CITY OF ALBUQUERQUE

**RE: Lot 14 Block 7A Unit 3 SAD 227
6119 Little Joe Dr. NW
Grading and Drainage Plan
Engineers Stamp Date 5/19/2020 (E10D078)
Pad Certification Date 6/8/2020**

DRAINAGE AND TRANSPORTATION INFORMATION SHEET (REV 6/2018)

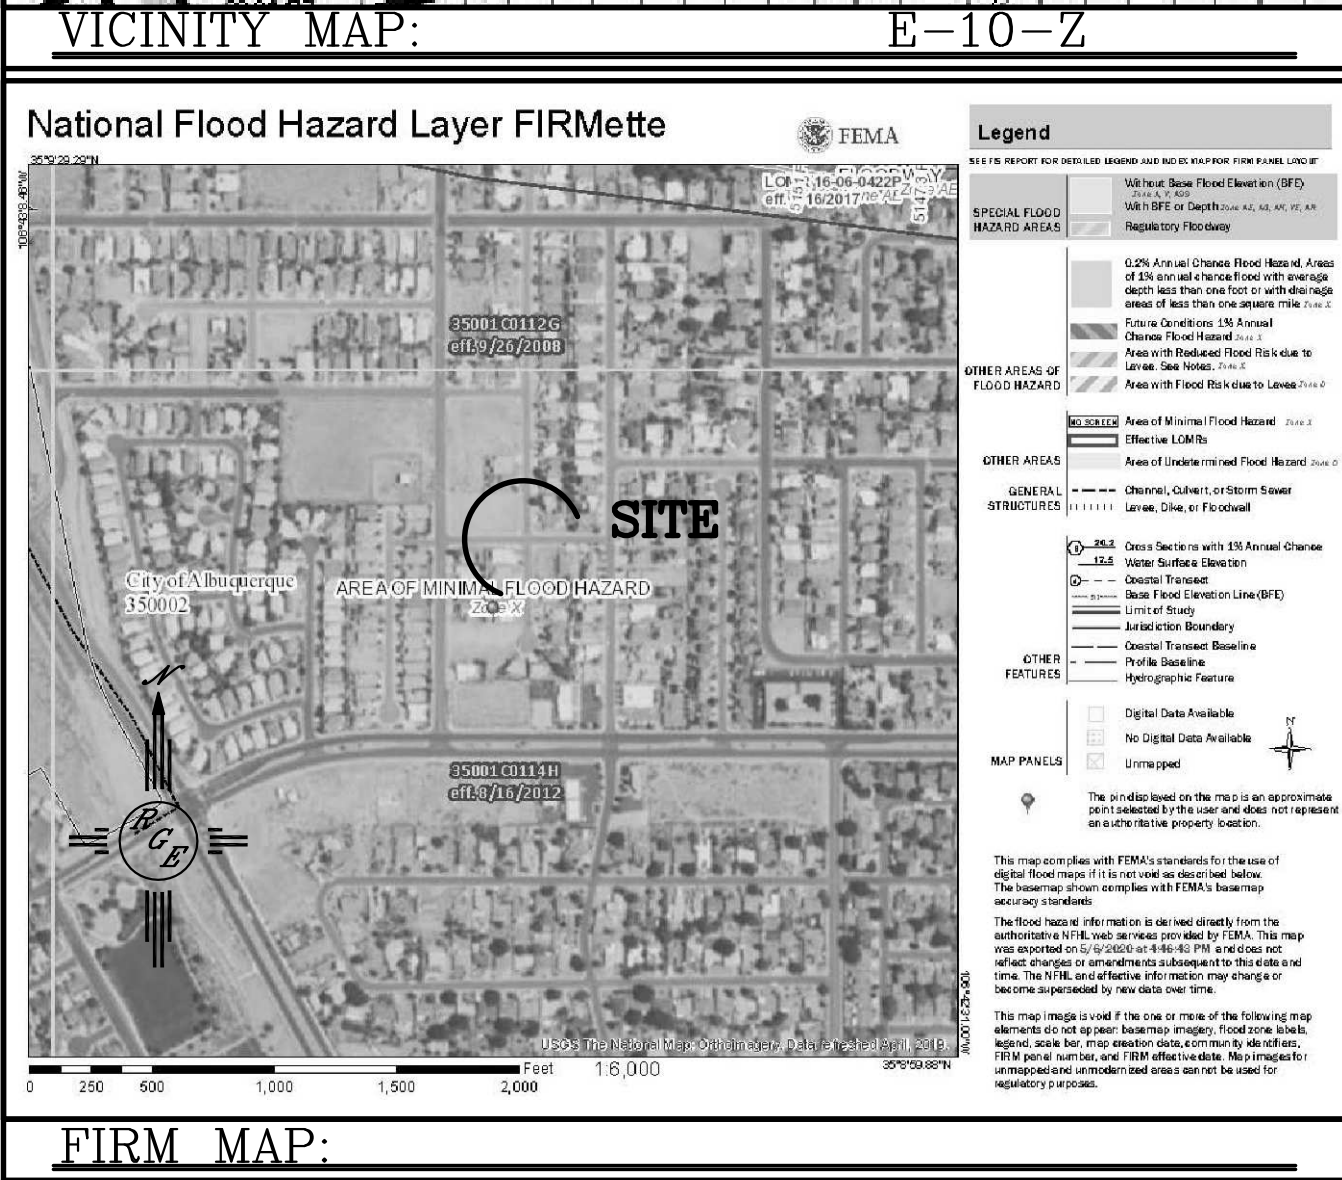
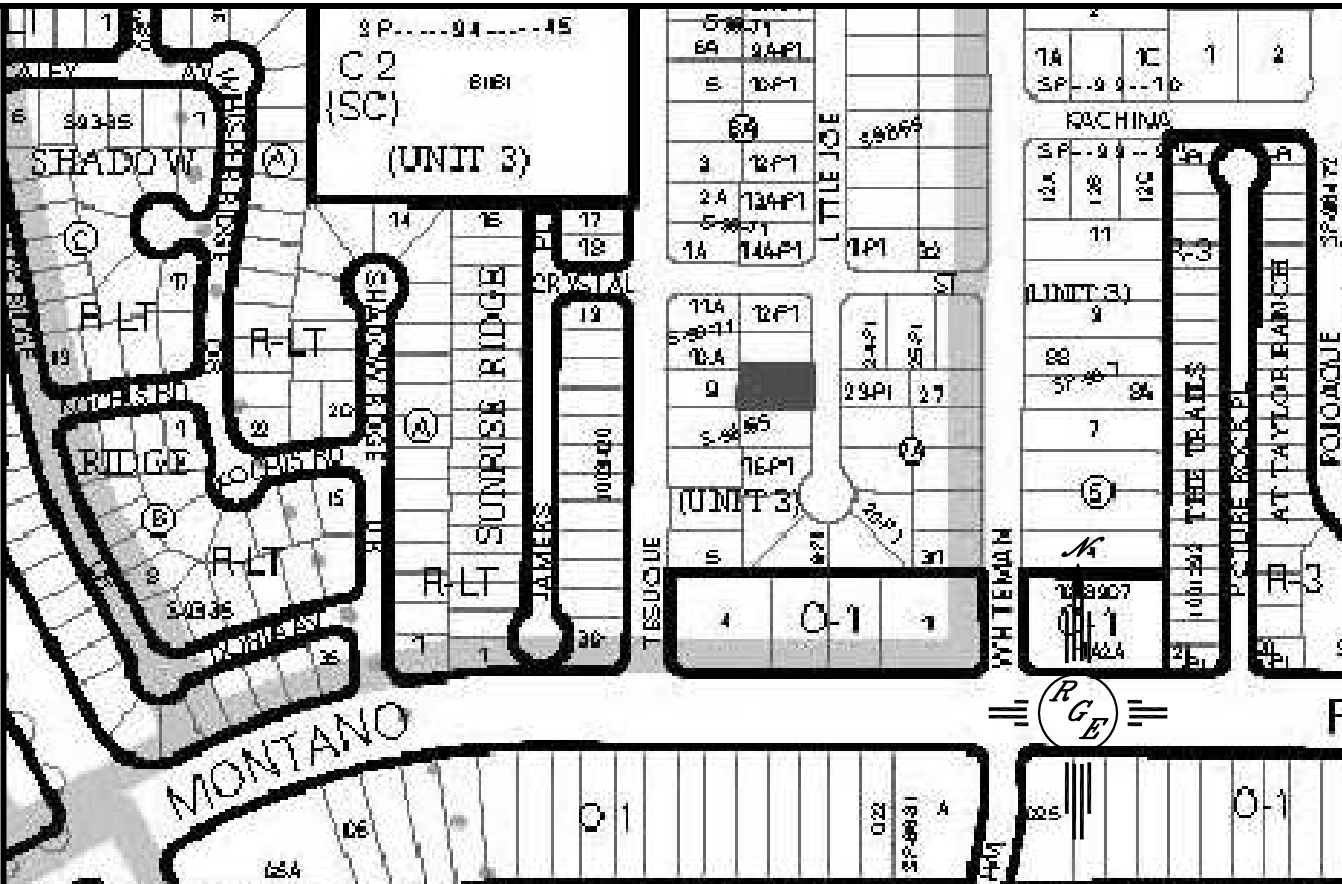
Based upon the information provided in your submittal received 6/9/2020, this plan is approved for Building Permit.

Reiterate to the Owner/Contractor that a separate permit for a garden/retaining wall must be obtained, with the approved G&D plan dated 5/13/2020.

Prior to Certificate of Occupancy release, Engineer Certification per the DPM checklist of this plan will be required.
